CPV Towantic, LLC  
Docket No. 192B

Interrogatories Middlebury Bridle Land Association-1  
Dated: 2/24/2015  
Q-MBLA-3  
Page 1 of 1

FIGURE 4.2-7  
VIEW 1: FROM BRIDLE TRAIL BY  
TOWANTIC POND TOWARDS SITE

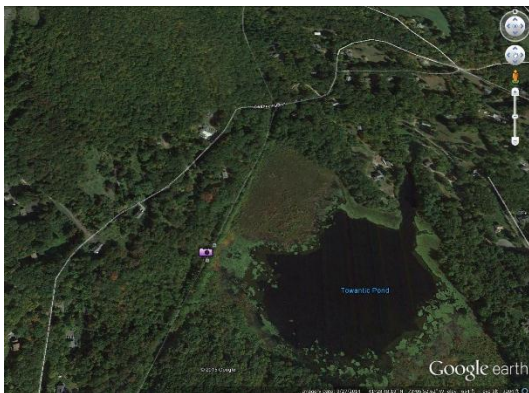
Will any flashing lights be visible to horses/equestrians riding along the Larkin State Bridle Trail?

The Larkin State Park Trail is canopied with deciduous trees for most of its 10.4 miles, as described by the Trail Link website (<http://www.trailink.com/trail/larkin-state-park-trail.aspx>) and evidenced by the attached photographs taken near the site. The original Council application included the attached visual simulation from a location on the Larkin Trail near Towantic Pond, looking towards the site. In this location, the simulation indicated that only the top of the stacks could be viewed at a distance above the intervening vegetation. The stacks are anticipated to require lighting within 20 feet of the stack tops in accordance with FAA requirements. Therefore, it is possible that riders looking through certain portions of the trail's treeline could have a distant view of those lights.
